SONOCUR

Service Instructions

SP006/03/I**Title: Sporadic Error 63**

Fig. 1

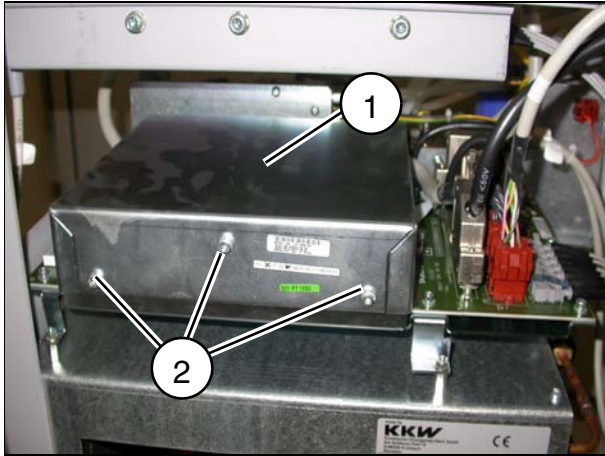
- Switch off the system and disconnect it from the mains.
- Remove the two side covers.
- Remove the EMC cover (1/Fig. 1) of the circuit board D3 after loosening the screws (2/Fig. 1).
- Remove PROM J7 and PROM J10 (1/Fig. 2) from the piggy-back board D332 which is located on the circuit board and replace them with new PROMs.
- Refit the EMC cover and fasten it.
- Refit the covers.
